PCI-SIG ENGINEERING CHANGE REQUEST

TITLE:	Add USB 3.0 to the Mini Card
DATE:	August 86, 2014
AFFECTED DOCUMENT:	PCI Express Mini-CEM 2.0
SPONSOR:	Jim Panian, Qualcomm

Modify the Mini Card specification to enable USB 3.0.

Figure 0-12: Logical Representation of the PCI Express Mini Card Specification

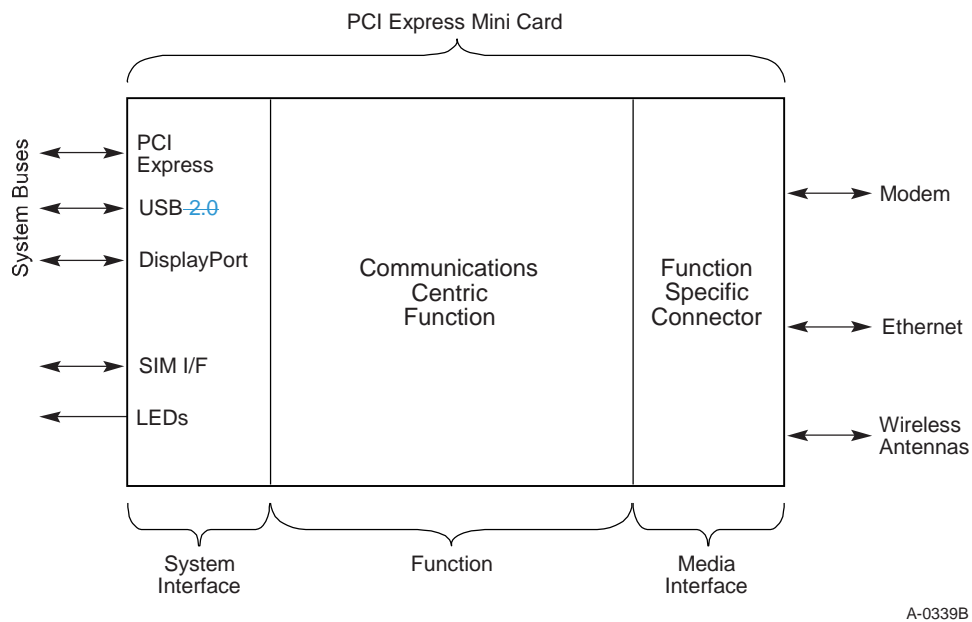
Change Section 2.1, Overview, Figure 1-2 on page 8 as follows:
